Addendum #4
Project #2767A
Brown County Port Development Project
Port & Resource Recovery
October 31, 2025
Request for Bid

Addendum #4

- To start answering questions received for project

C-504

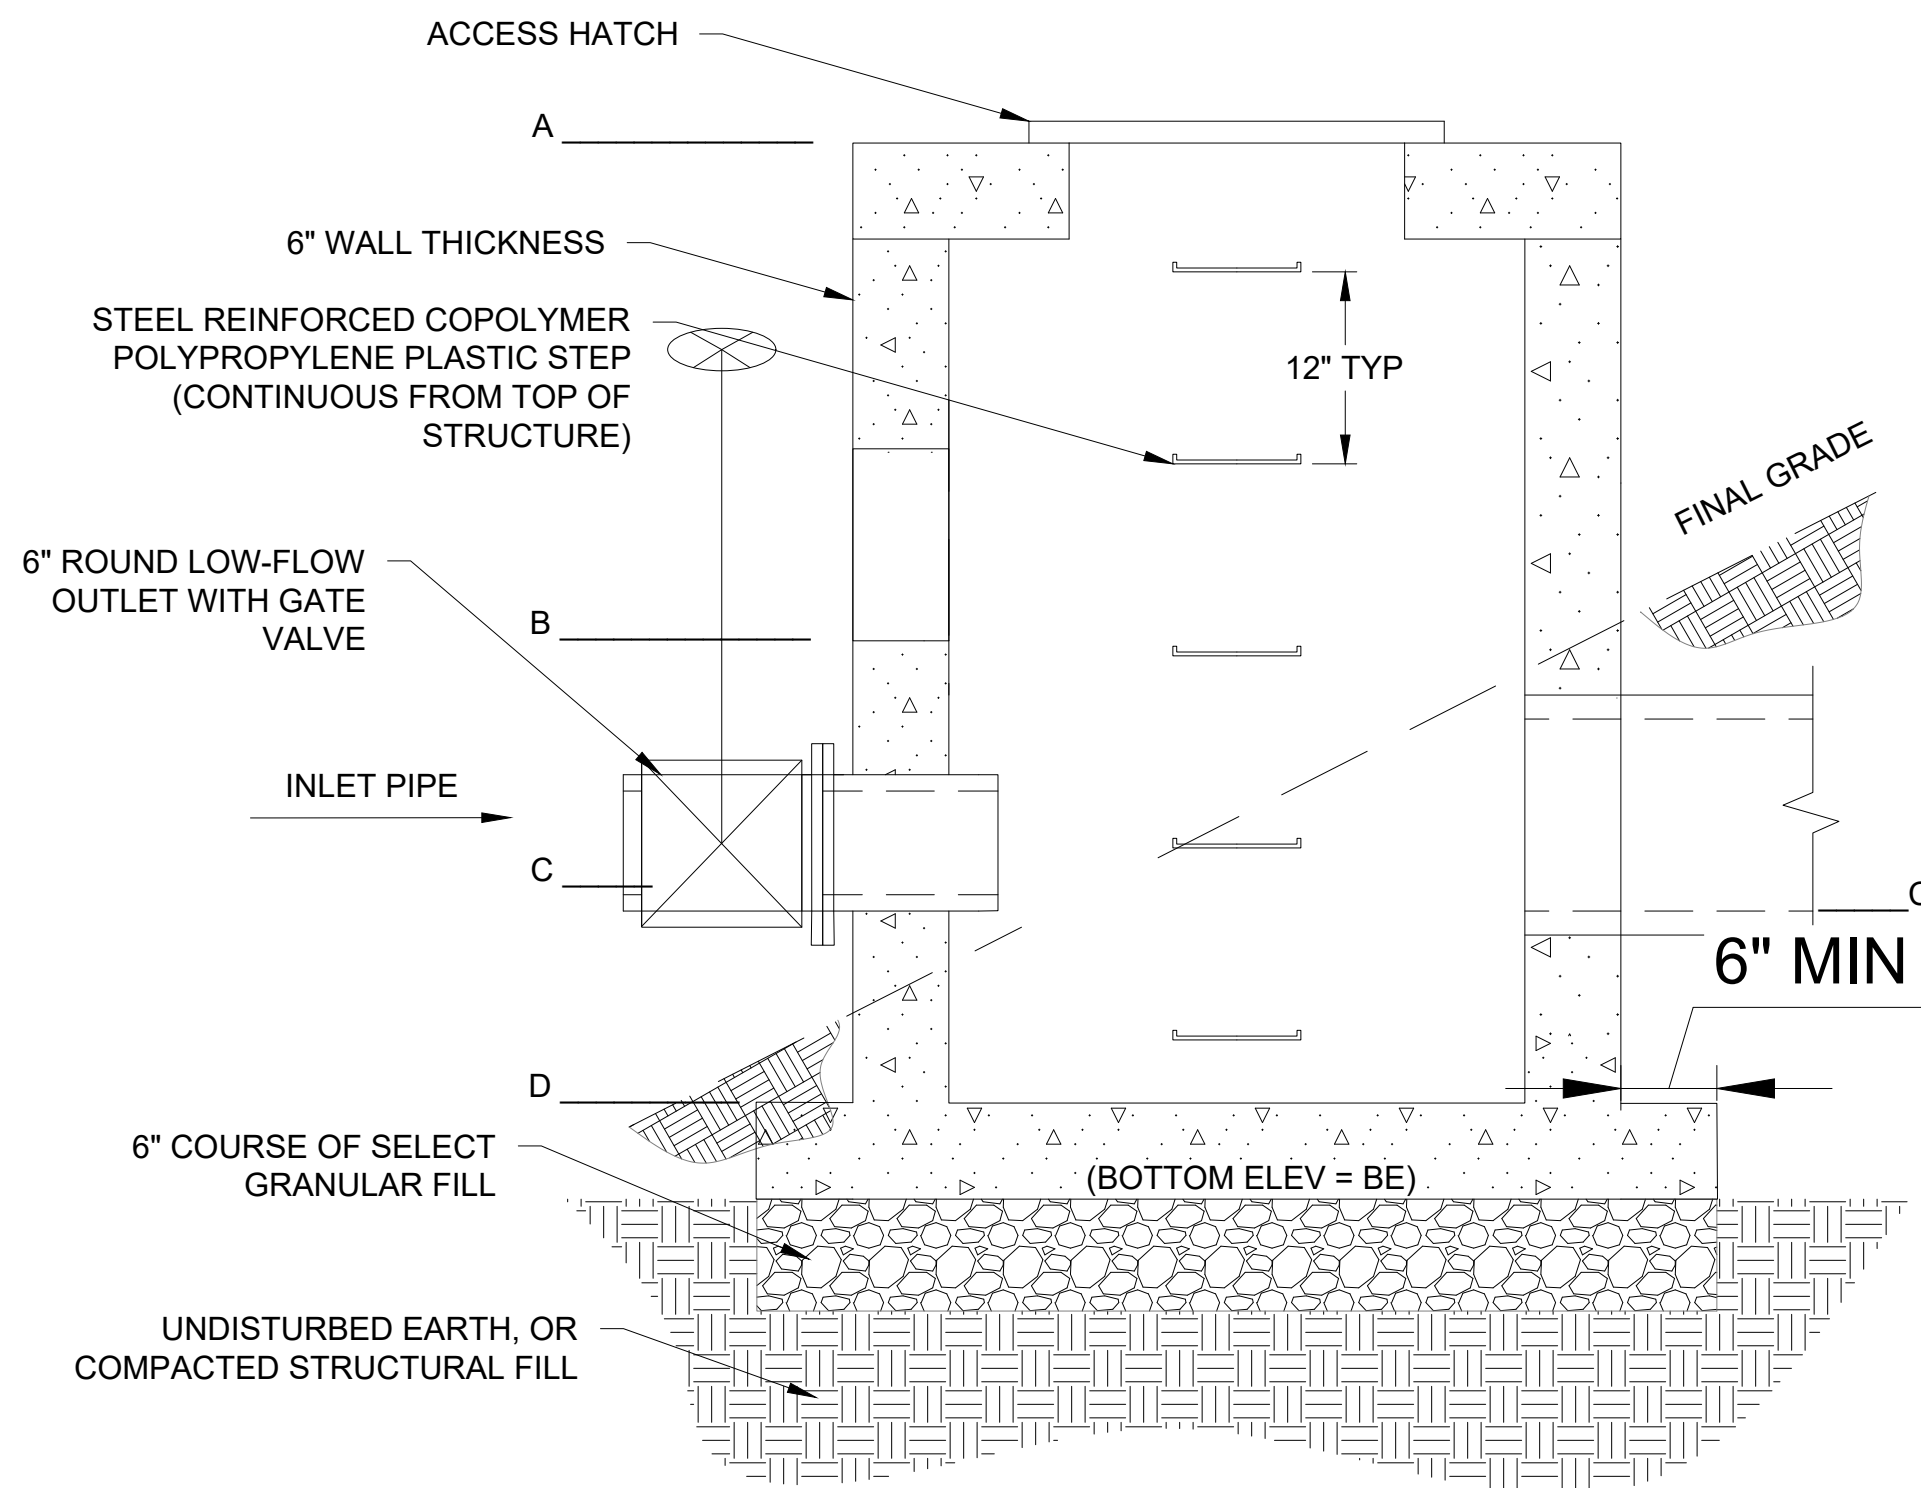
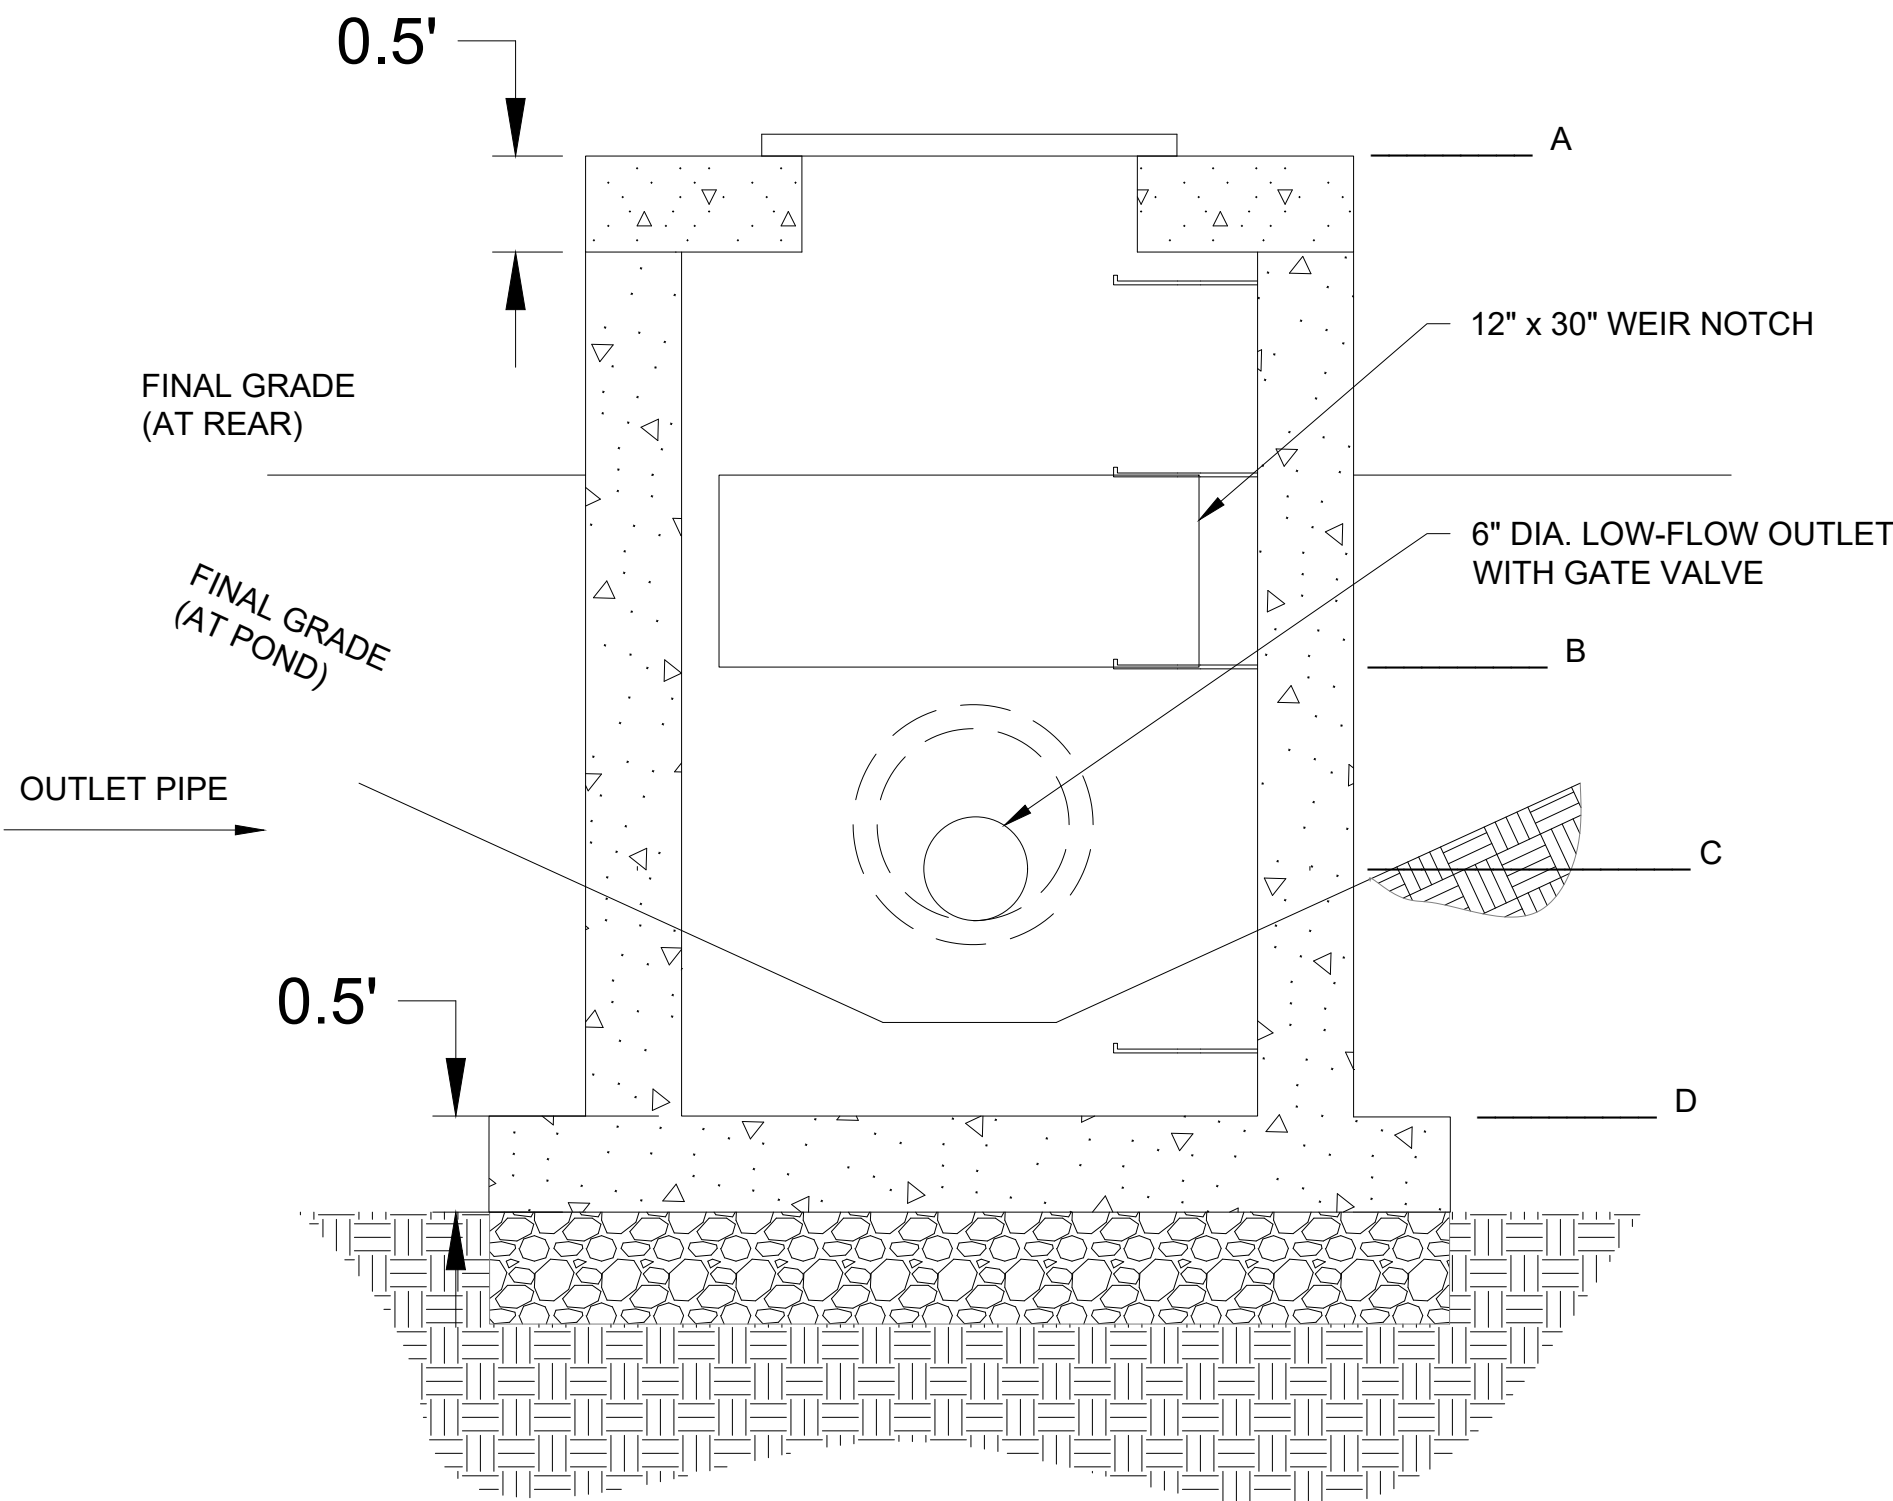
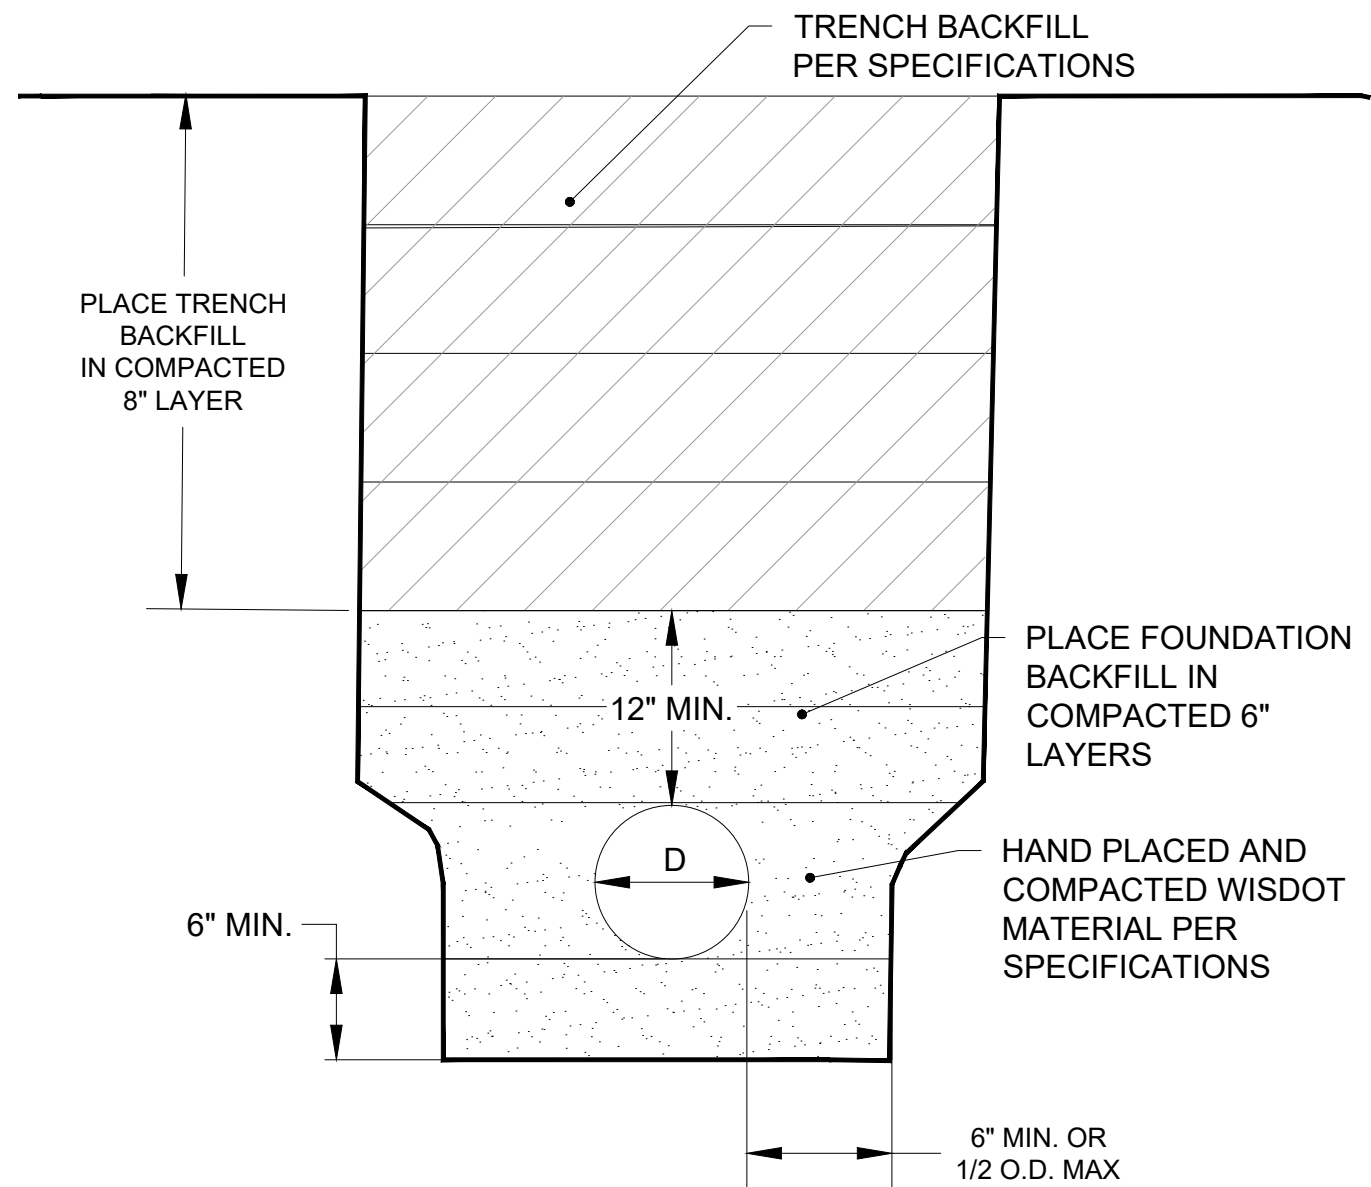
17. **QUESTION:** For Bid Item 6.3 - Detention Pond Outlet Structures: It shows an inlet pipe with valve. What is the size of pipe and valve? Is there a certain type of pipe and valve? What is the elevation of D on the structure as noted in detail?

RESPONSE: The pipe and valve are 6 inches in diameter. Please assume a gate valve flanged to a section of 6-inch steel pipe. For stability of the structure, the elevation of “D” on the detail is 2 feet lower than the inlet/outlet pipe elevations for each structure. Additional detail has been provided on revised Sheet C-504 (attached).
